Subject: Response to Nuclear Regulatory Commission Request for Additional Information
Re: Alternative Source Term (TAC No. MD9921)
Cooper Nuclear Station, Docket No. 50-298, DPR-46

**Response to Nuclear Regulatory Commission Request for Additional Information
Re: Alternative Source Term (TAC No. MD9921)**

Cooper Nuclear Station, Docket No. 50-298, DPR-46

Figure 1 Suppression Pool pH with SLC Injection following DBA-LOCA

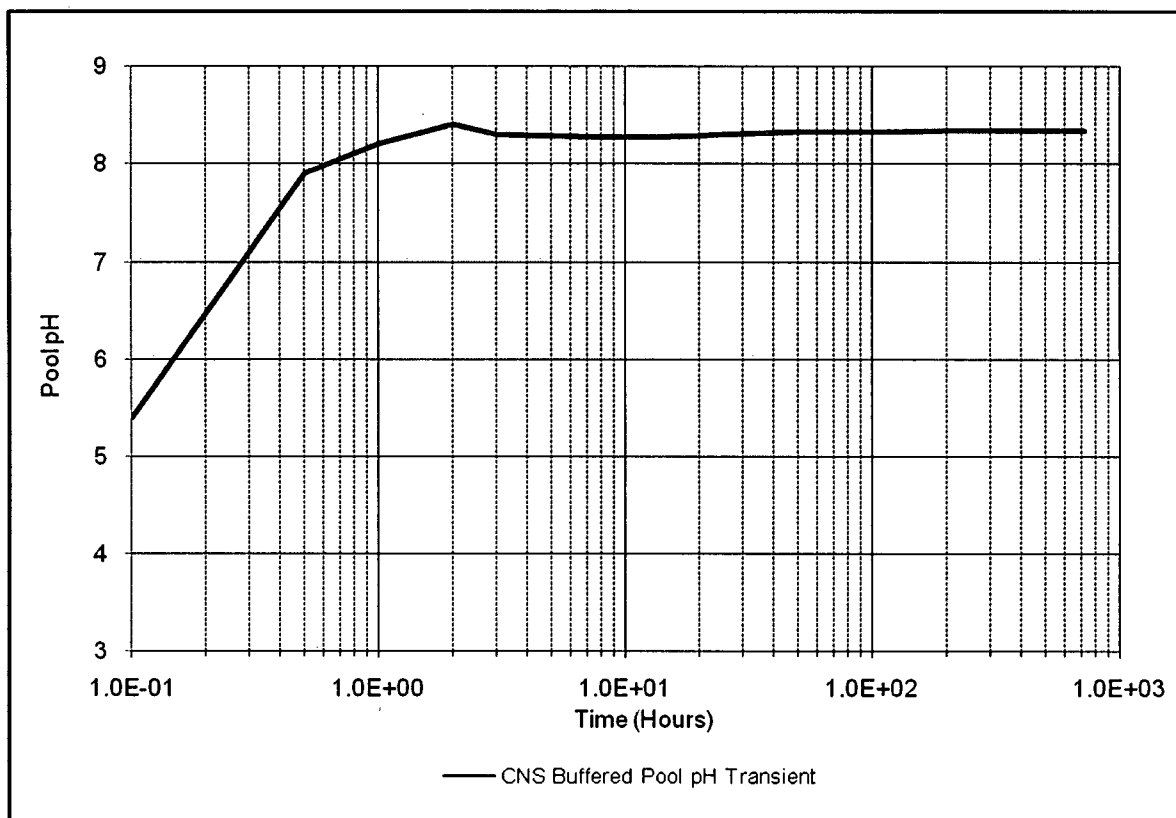
Provide a list and description of components being added to your Title 10 of the Code of Federal Regulations Section 50.49 (10 CFR 50.49) program due to this LAR. Confirm that these components are qualified for the environmental conditions they are expected to be exposed to.

Under DBA-LOCA conditions, significant quantities of acid are generated. Injection of sodium pentaborate decahydrate ($\text{Na}_2\text{B}_{10}\text{O}_{16} \cdot 10\text{H}_2\text{O}$) solution from SLC is credited with buffering the acidity and maintaining pH of the suppression pool inventory above 7.0 for the duration of the DBA-LOCA. Chemical composition of the suppression pool is representative of containment spray conditions after the spray system is manually initiated 10 minutes into the DBA LOCA. Figure 1 reflects the pH profile of the suppression pool following a DBA-LOCA with SLC injection.
